CONVAIR

COMMERCIAL CHANGE PROPOSAL

SPEC NO.: ZD- 22-002

MODEL: (880) 22-1

CCP No. 185A DOUBLE COACH FOOD TRAY

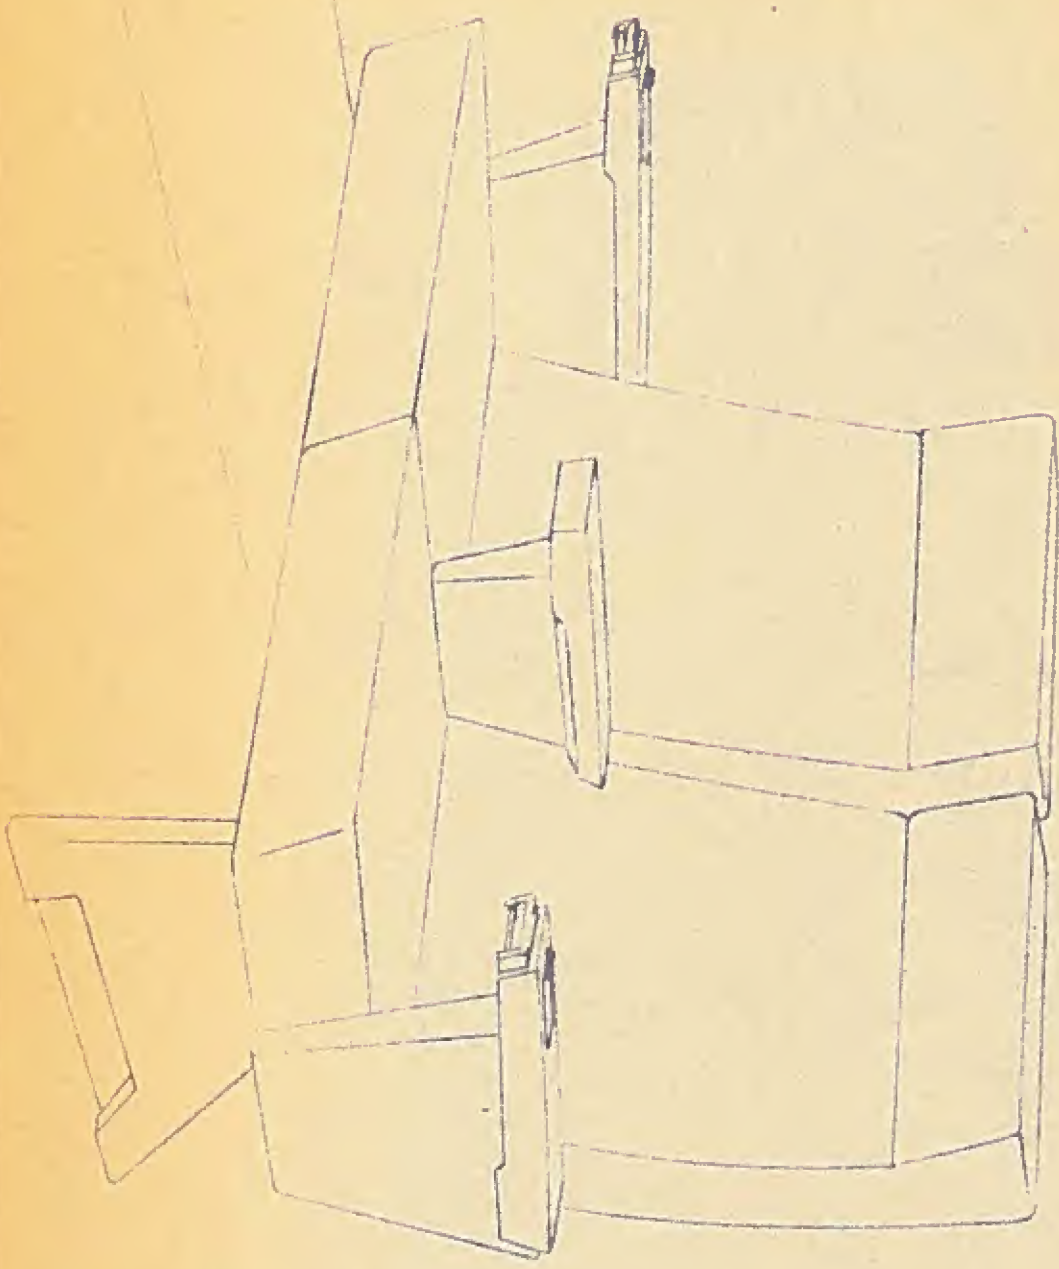
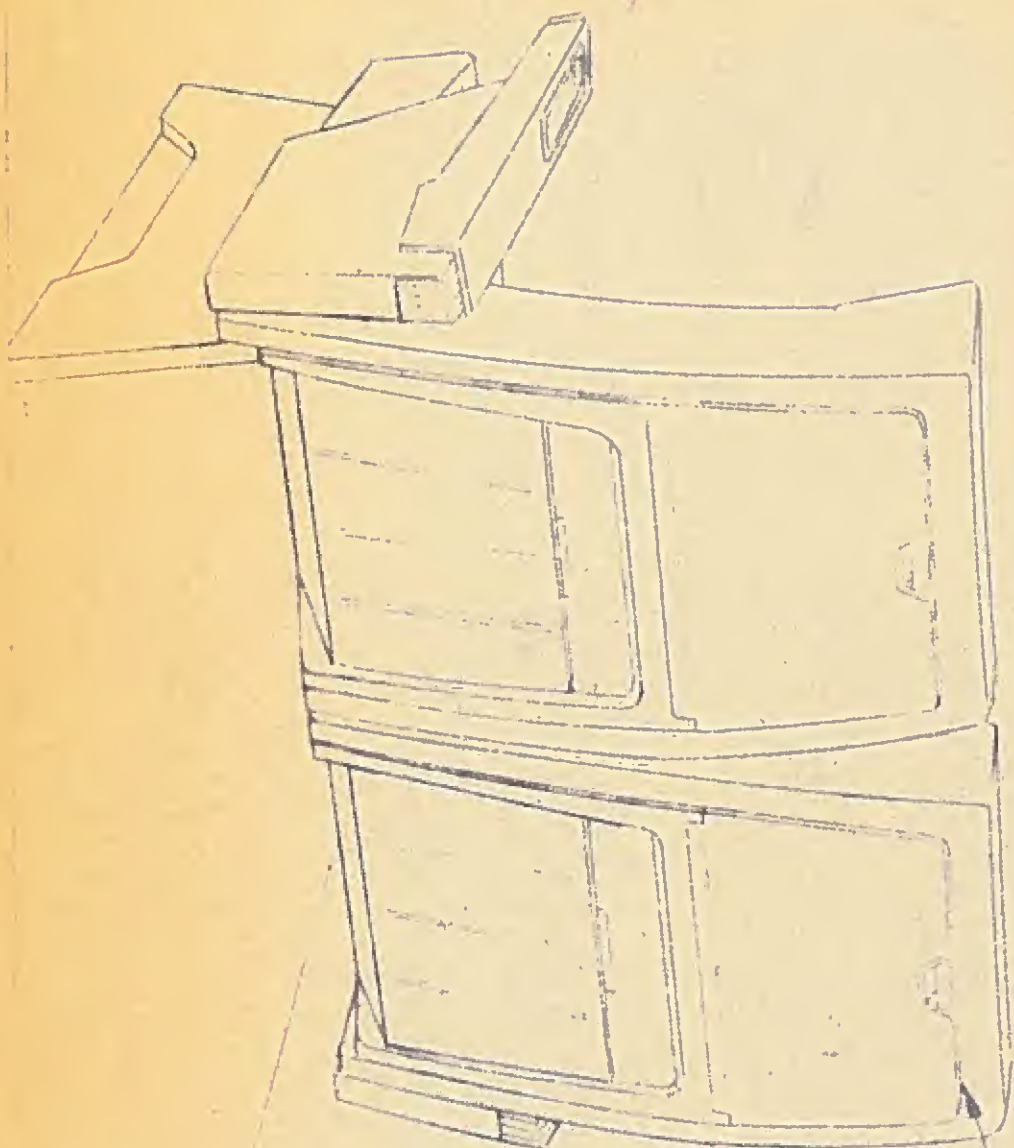
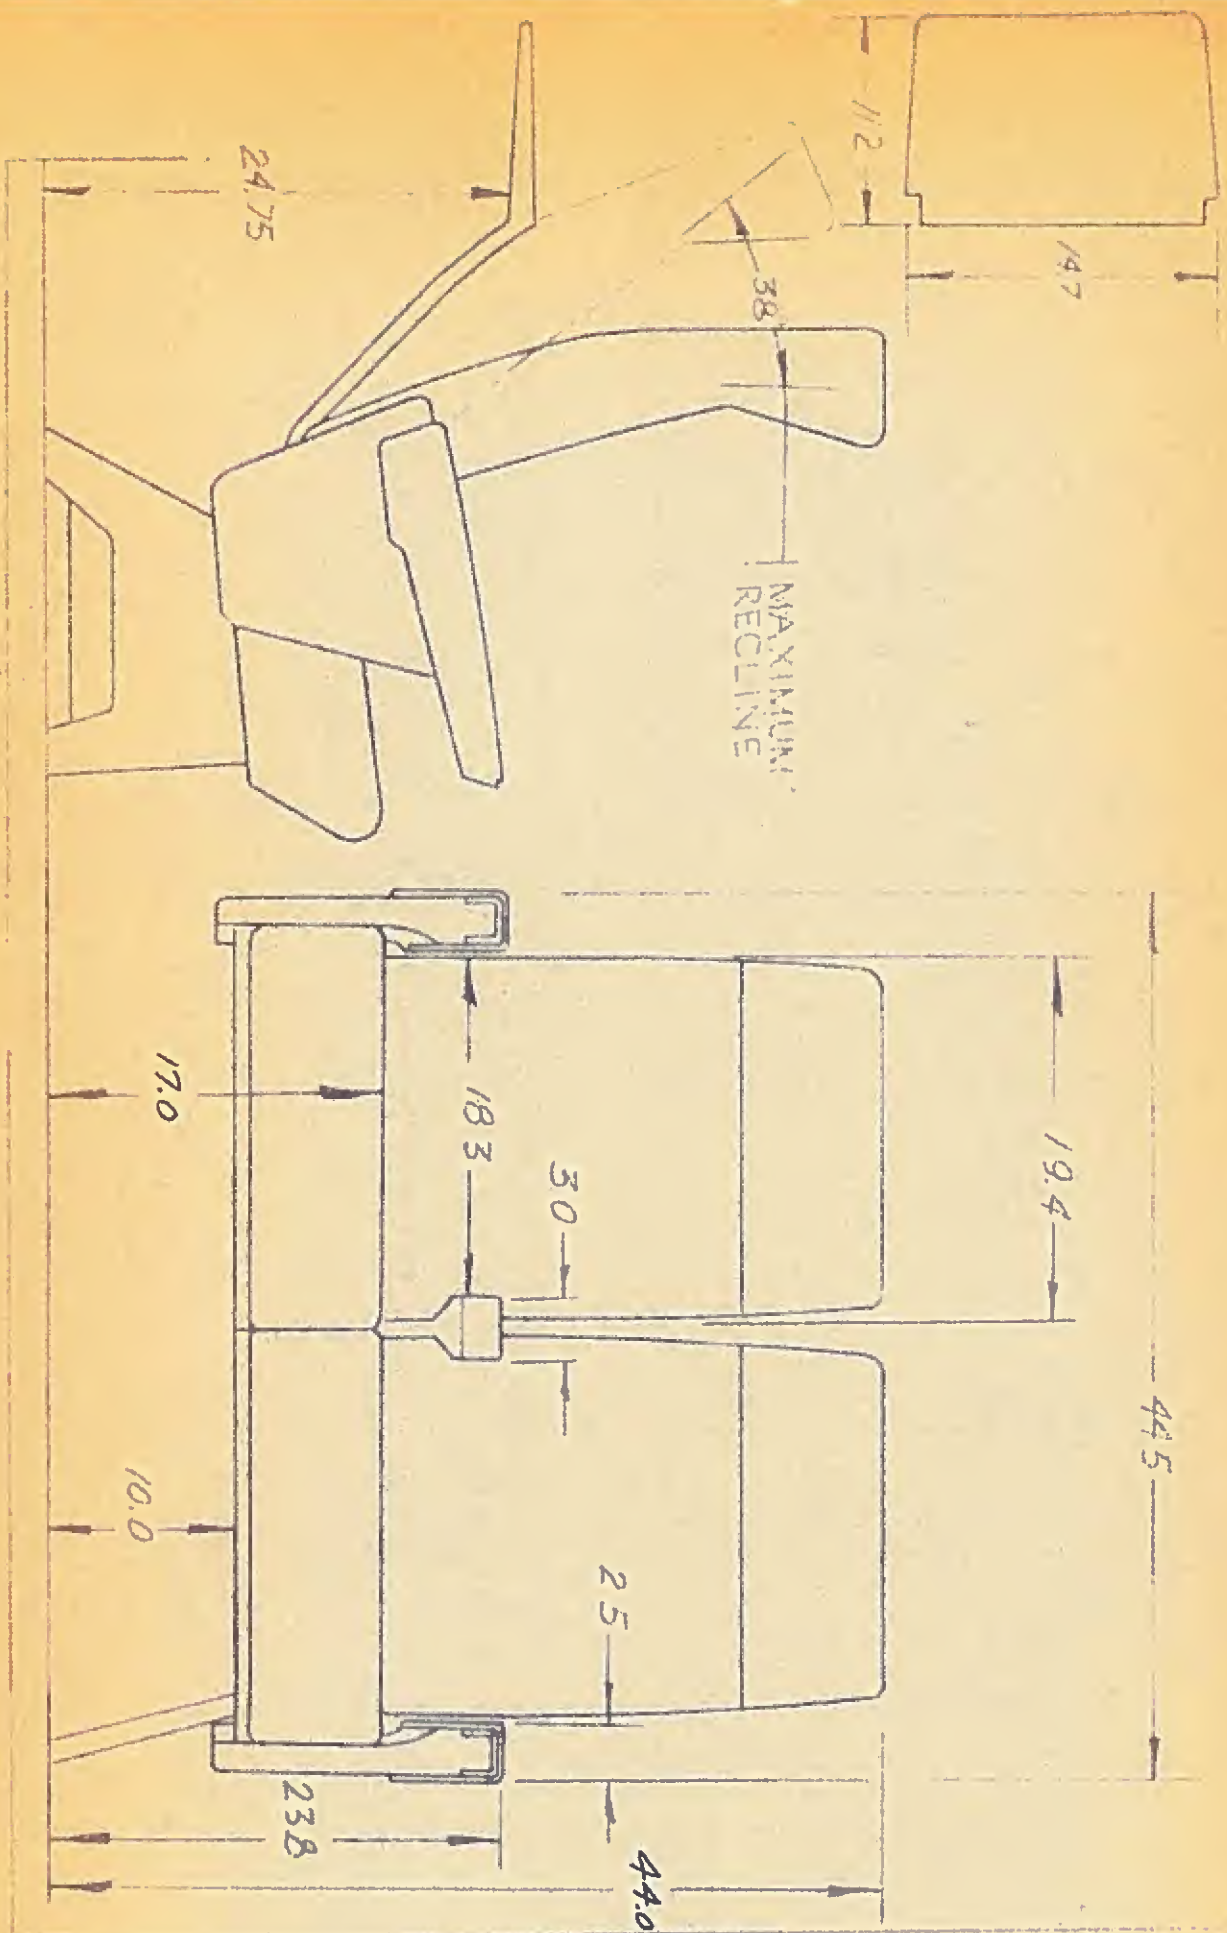
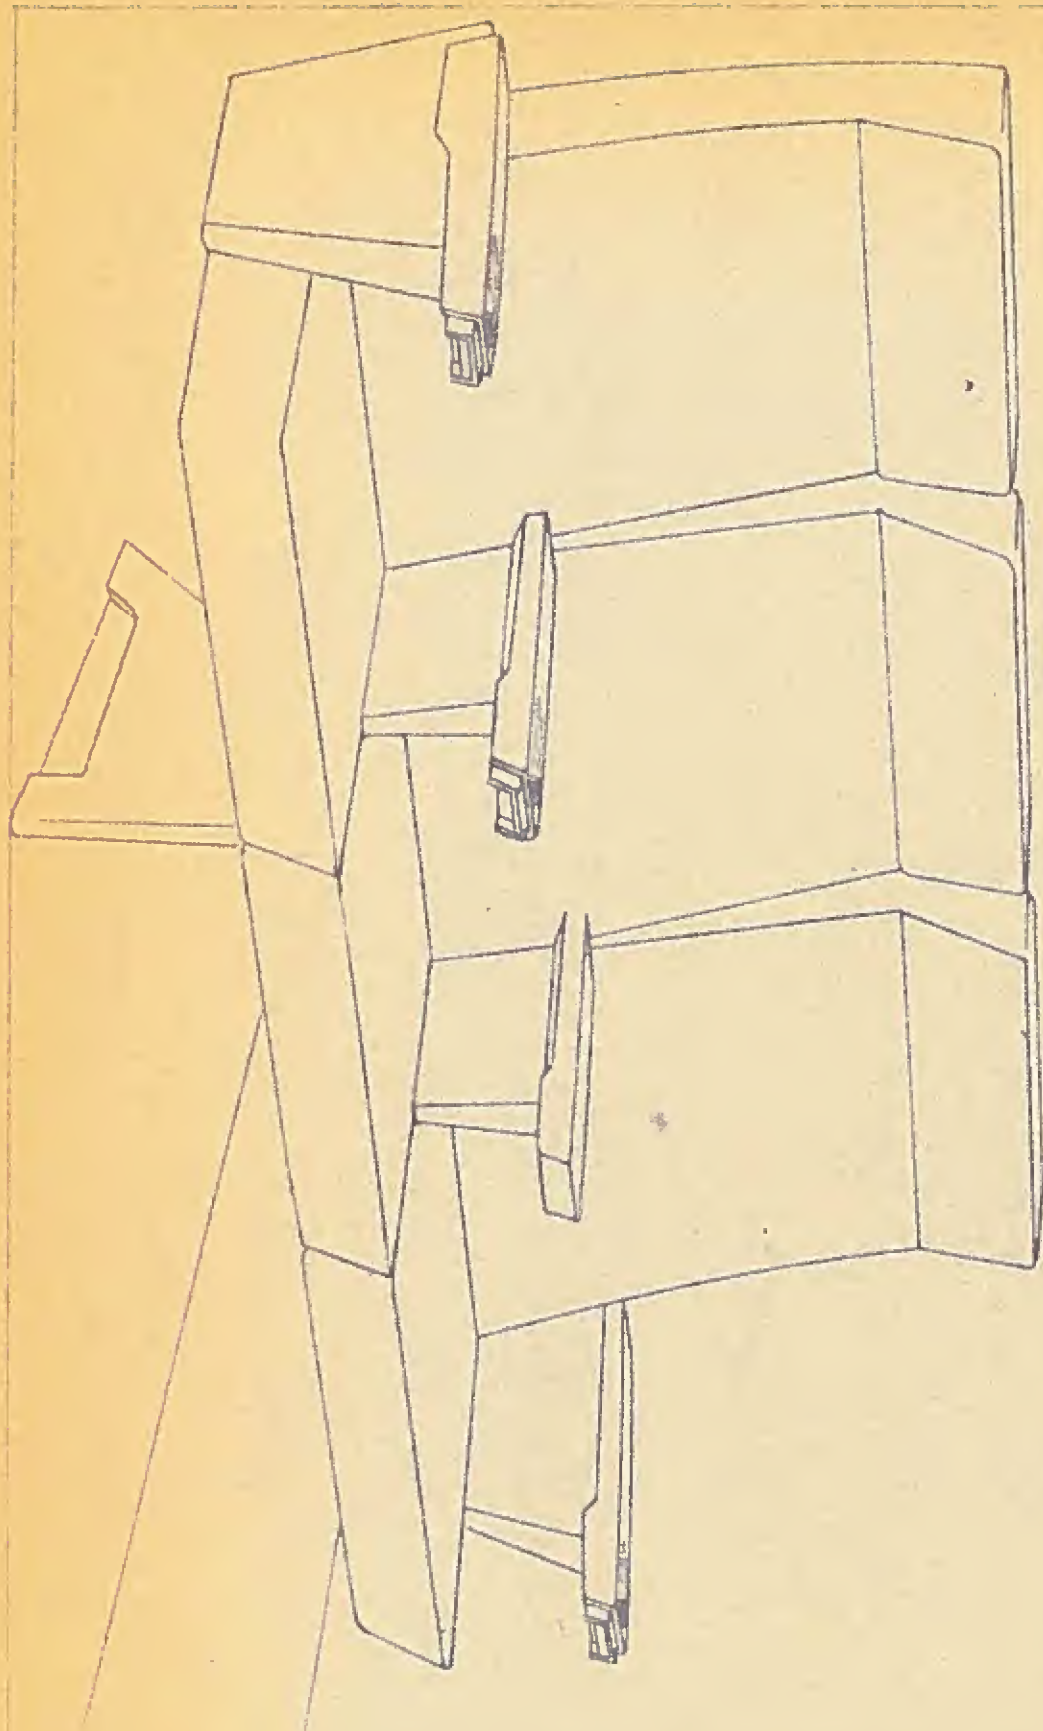
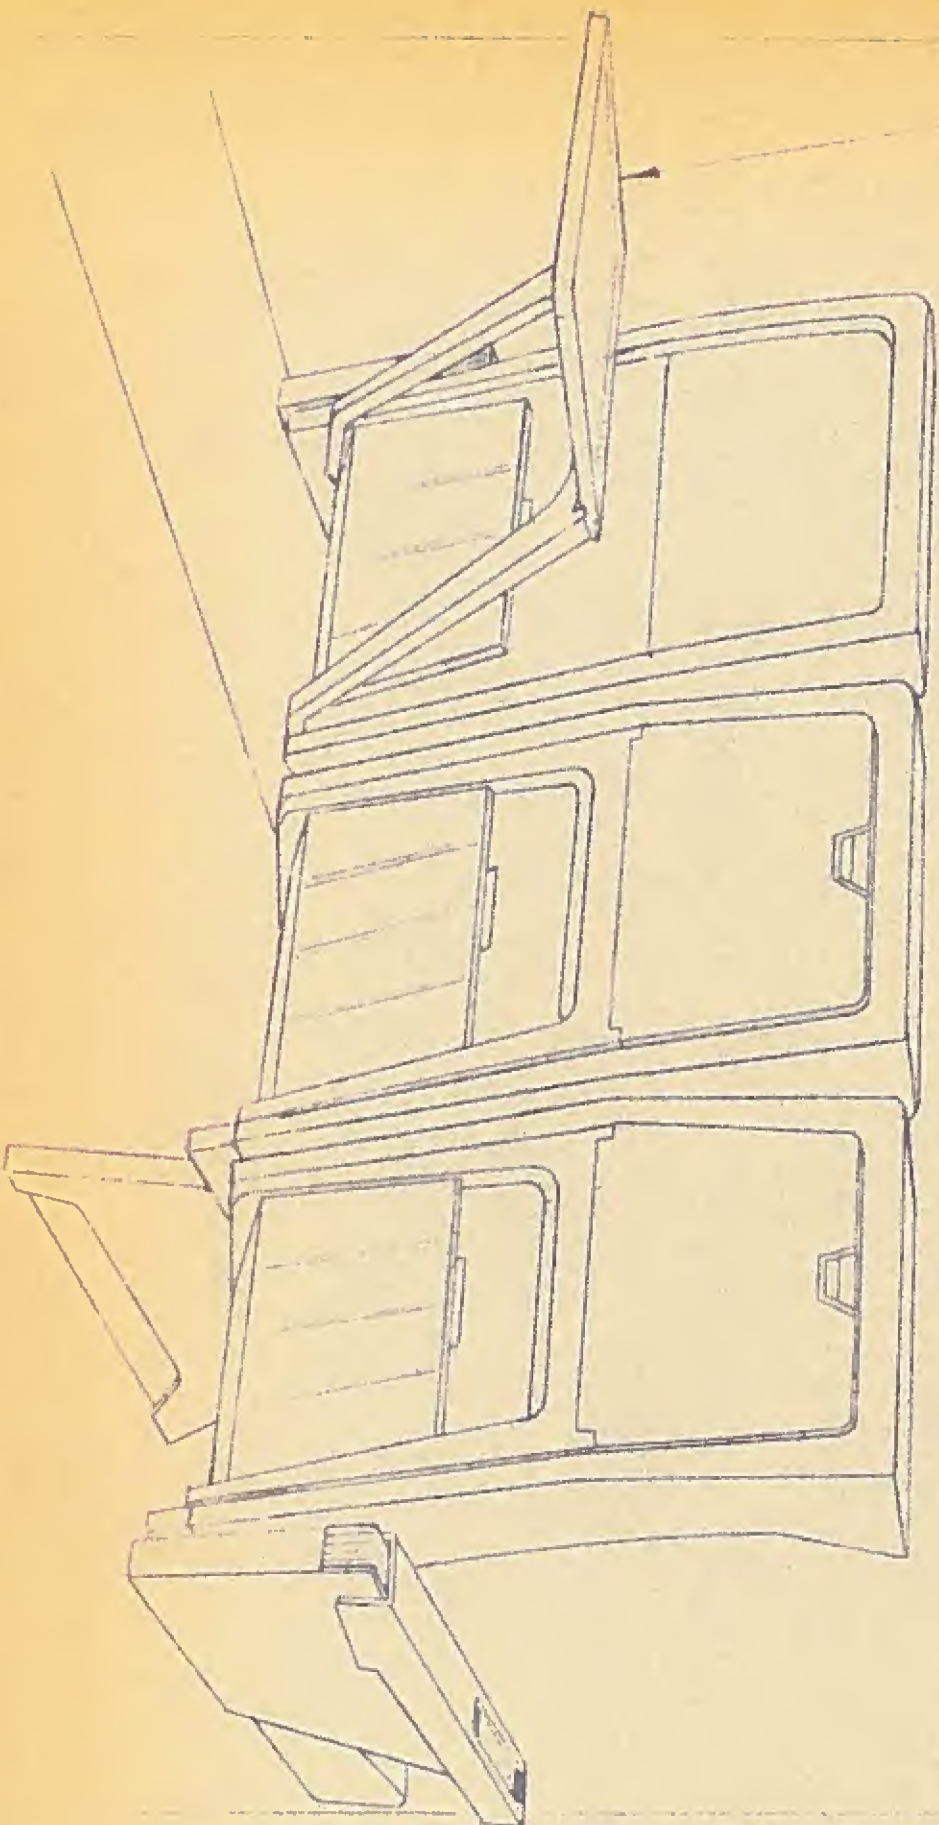
No mock-up or prototype coach seats have been included in this proposal.

Equipment interchangeability for standard seats, as covered in CCP No. 104B, is also applicable to coach seats.

Item "A" is paragraph 3.19.1.1.5.2 of this proposal, will provide five plug-in trays for first six rows of Customer order per airplane. Five additional plug-in trays will be provided for 18 or more coach seat rows per airplane. Receptacles for plug-in trays shall be provided as loose equipment on all coach seats not having receptacles installed.
